Supplemental to 2nd Submission

100, 108, 114 Emma Street South . Grand Valley . Ontario Summary Letter of Response

Project No 1724 EMMAVILLE RESIDENCES.

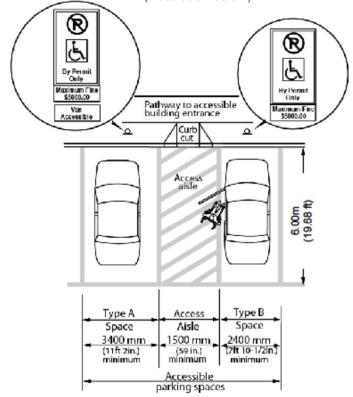
Barrier Free Parking: Ministry standards, ON. REG. 191.11.80.32 to 191.11.80.39:

- Type A Barrier Free parking: 3.4m width & is van accessible
- Type B Barrier Free parking: 2.4m width
- 1.5m Access Aisle can be shared by 2 Barrier Free parking space
- 1 Type A space is required for the first 12 parking spaces, 4% to be Barrier Free for # of parking between 13 & 100 parking, may be either type A or B in pairs. Type B if total parking number is an odd
- Town of Grand Valley Zoning By-Law: 4.6x6.0m for barrier Free parking

Proposed Barrier Free Parking : 1 Type A + 1 Type B stalls to Ministry's Standards (Illustration below)
